**Re: Addendum No. 2**  
**South Interceptor Equalization Improvements**  
**City of North Olmsted, Ohio**

Date: October 18, 2024

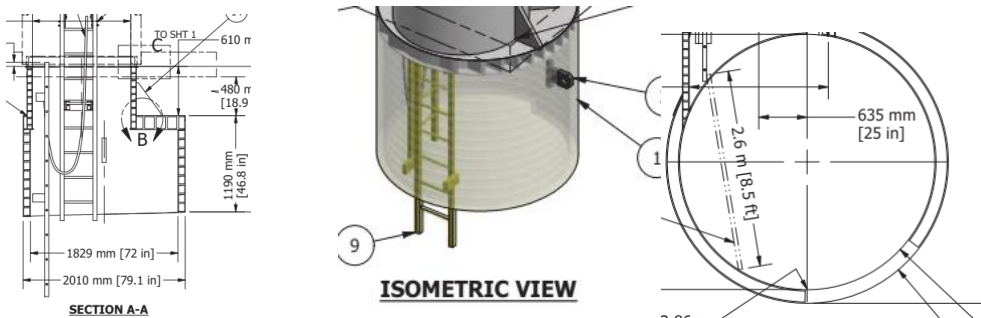
14. Dwg 20D-01 & 02 Can the MH Risers on the tanks be centered on the manifolds and moved slightly away from manifold fabrication stubs? **ANSWER** Such modifications noted below are acceptable and will be illustrated in the Conformance plans.

- i. Centered for safety reasons for personnel descending the ladder. As depicted on 20D-02 a person would be stepping off the ladder directly onto the curvature of the slippery pipe. Recommend centering and using a retractable ladder from obvert of pipe down to invert. See screen shot below example of retractable ladder used on another 132” tank project. They could not center the riser but at least the retractable ladder could reach more toward the invert of the pipe and dismounting the ladder on less of the pipe curvature. Being able to center the riser eliminates dismounting the ladder on the pipe curvature altogether

- ii. Away from manifold fabrication stubs and re-enforcements for ease of fabrication
